**RESPONSE  
TO THE EIR-TEAM INITIAL QUESTIONS  
FOR THE  
EXTERNAL INDEPENDENT REVIEW**

**National Compact Stellarator Experiment  
(NCSX)  
Princeton Plasma Physics Laboratory  
Oak Ridge National Laboratory**

14 November 2003

**Figure 2**  
**Final assembly flange joint for modular coil shell**

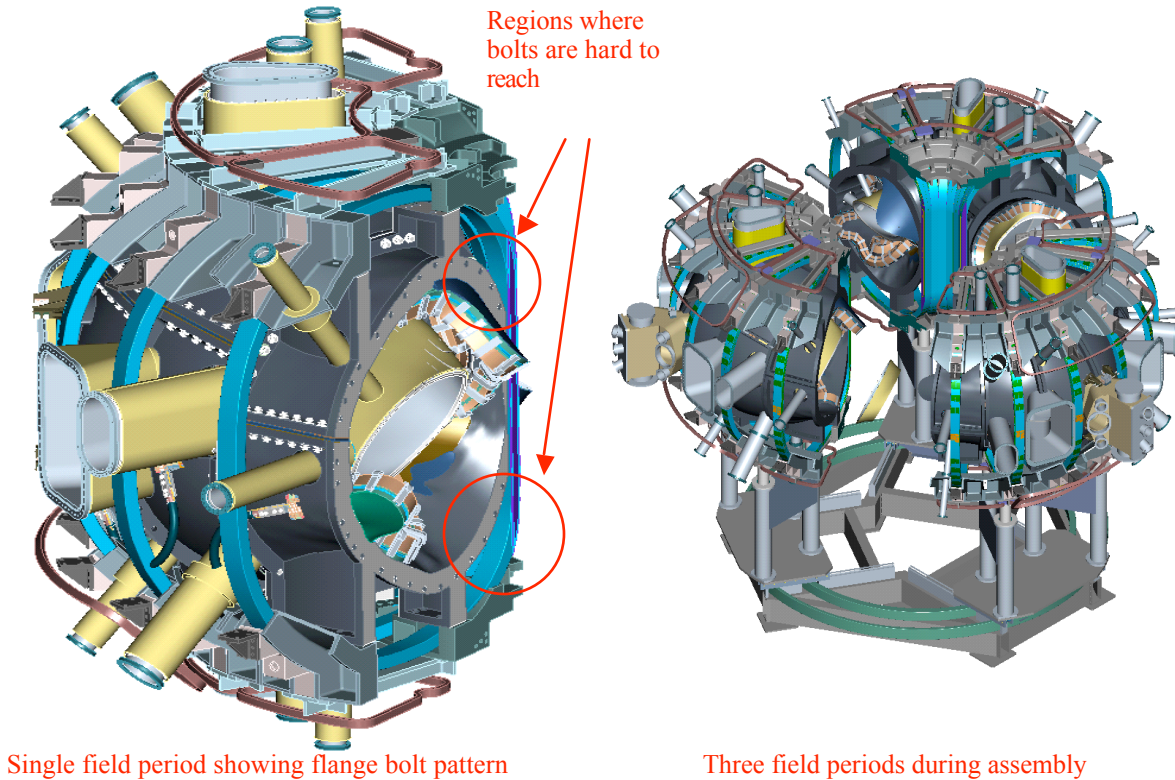
2. *The Preliminary Design Review recommended that the Project address the issue of lack of access for bolt installation and tightening of fasteners between field period assemblies in the inboard area. How has the Project resolved this issue?*

Background: The modular coil structure consists of individual winding forms that are bolted together to form a continuous toroidal shell. The bolting sequence starts by bolting 3 coils together to form a half field period, then bolting this half field period to an identical set of three coils to form a full field period, then bolting three field periods together to form the complete structure. The bolt pattern shown at the PDR included some bolts that were hard to reach during this final assembly step, bolting the three field periods together. Figure 2 illustrates the bolts that are hard to reach.

The approach to solving this problem will follow two steps. The first step will simply determine which bolts are difficult to reach. The second step will explore whether any of these bolts are actually needed to provide an adequate structural arrangement. The principal loading direction on the modular coils is inward in all cases, causing the inboard region of all the connecting flanges to be in compression. The only requirement for bolts in these regions is for shear purposes. The shear capability can be provided by pins, which in principal can be blind, or by friction, which would be provided by the compressive magnetic loads and by the preload afforded from the bolts located in the outboard regions of the mating flanges. It is very probable that the bolts which are difficult to reach can be eliminated from the design.
